Memorandum

To: Sanitary Sewer Board
From: Tim Crawford
Subject: Known and requested change order information
Date: March 31, 2026
CC: Donna Coomer

CITY OF CHARLESTOWN, INDIANA
 HIGHWAY 62 SANITARY LIFT STATION
 AND FORCE MAIN REPLACEMENT
 PROPOSED LIFT STATION SITE PLAN

PROPOSED LIFT STATION SITE PLAN
SCALE: 1" = 40'

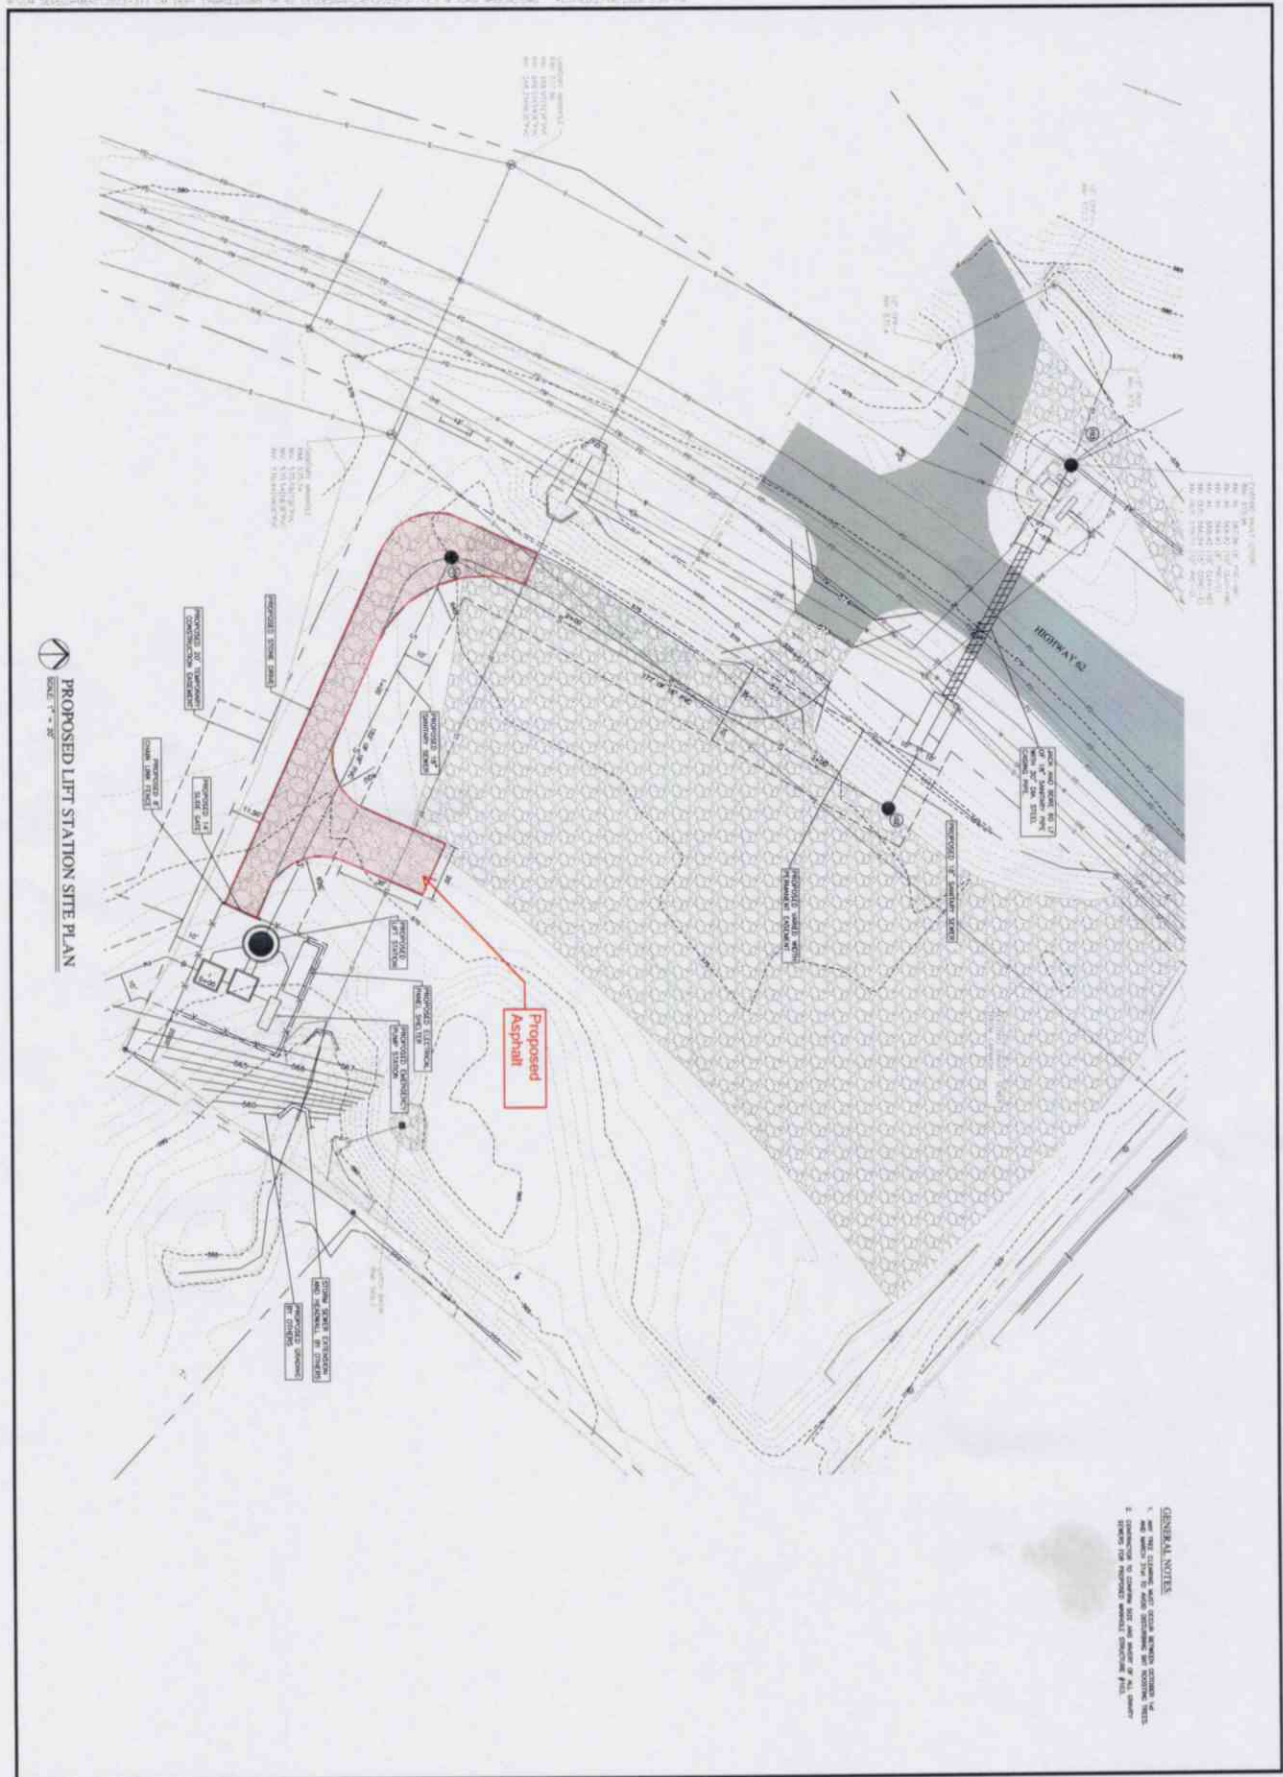
Total Contingency	\$250,000
Known Extras (not executed)	
Sewer Adj due to Utility Conflict	< \$21,872 >
4" Plug Valve on Emergency Discharge	< \$5,044 >
Temporary Road Drainage	< \$5,000 >
Utility request Asphalt for access road	< \$24,000 >
Remaining Contingency	\$194,084
